CERTIFICATE OF THE SECRETARY OF ENERGY AND ENVIRONMENTAL AFFAIRS
ON THE
DRAFT ENVIRONMENTAL IMPACT REPORT

PROJECT NAME	: Massachusetts General Hospital 2019 IMP Projects
PROJECT MUNICIPALITY	: Boston
PROJECT WATERSHED	: Charles River
EEA NUMBER	: 16012
PROJECT PROPONENT	: The Massachusetts General Hospital and The General Hospital Corporation
DATE NOTICED IN MONITOR	: May 10, 2021

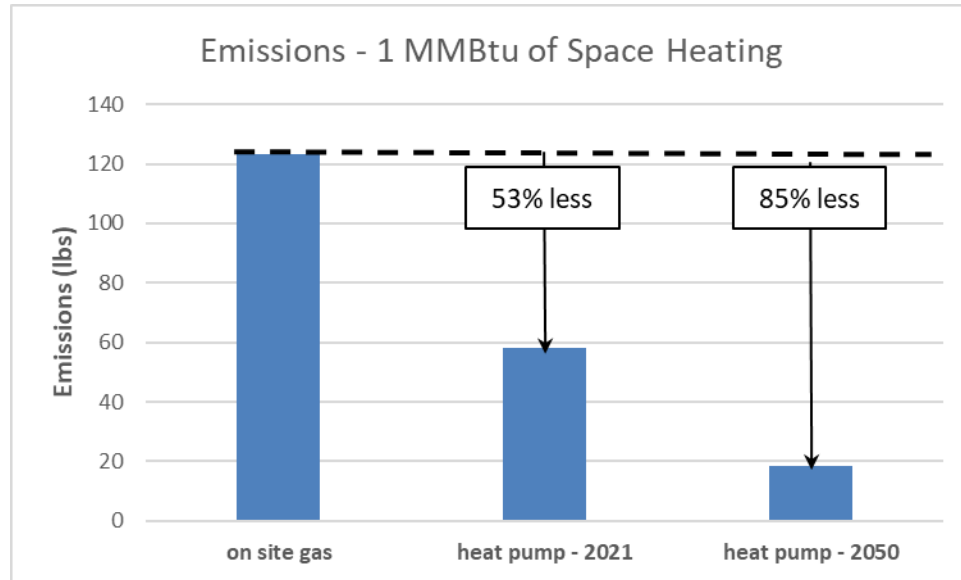
Below is a summary of key envelope commitments. The building is proposing a 7% improvement in vertical envelope and reduced air infiltration per C406.9 (air infiltration of 0.25 cfm/sf at 75 Pa, or less, as verified by field testing). Code roof assembly is proposed.

Building	Vertical UA		Roof R value		Air infiltration	
	Commitment	% Improvement over Code	Commitment	Code Requirement	Commitment	% Improvement over Code
Hospital	0.147	7.1%	R-30c.i.	R-30c.i.	0.25 cfm/sf at 75 Pa	Equal to code – C406.9

1. Revise the reported emissions for Baseline as described above using electricity and gas only. For the proposed, when calculating emissions for Vicinity district steam, use 193 lbs/MMBtu.
2. Maintain envelope and electrification commitments described above as these significantly reduce heating and cooling TEDIs and improve GHG mitigation level. Consider alternatives for supplemental heating to maintain the GHG gains from the project.
3. Clarify solar PV commitment and PV readiness commitment.
4. Clarify EV readiness and EV equipment commitment.

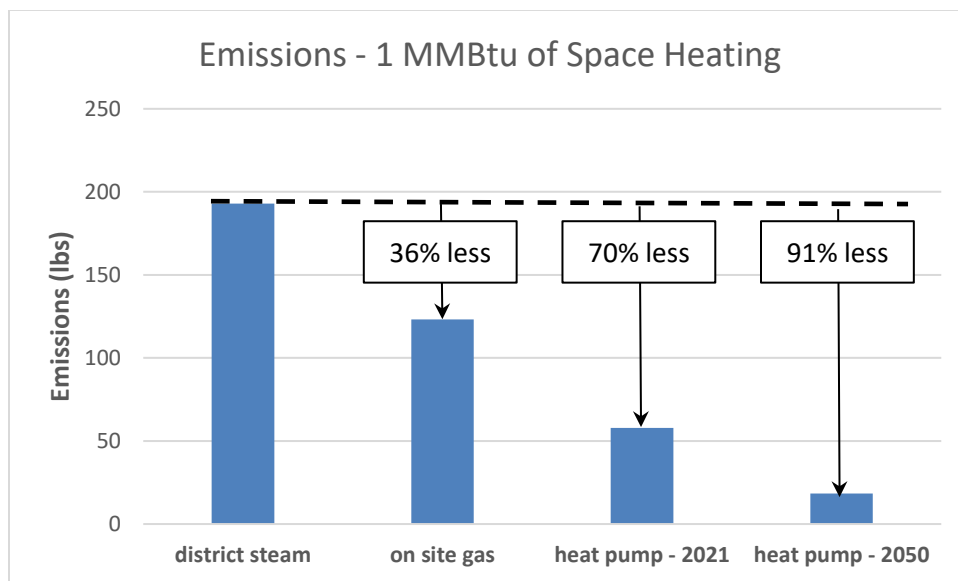
The above strategy reduces water heating by 63%. The project should be commended for this innovative approach.

The balance of water heating is provided by Vicinity district steam.
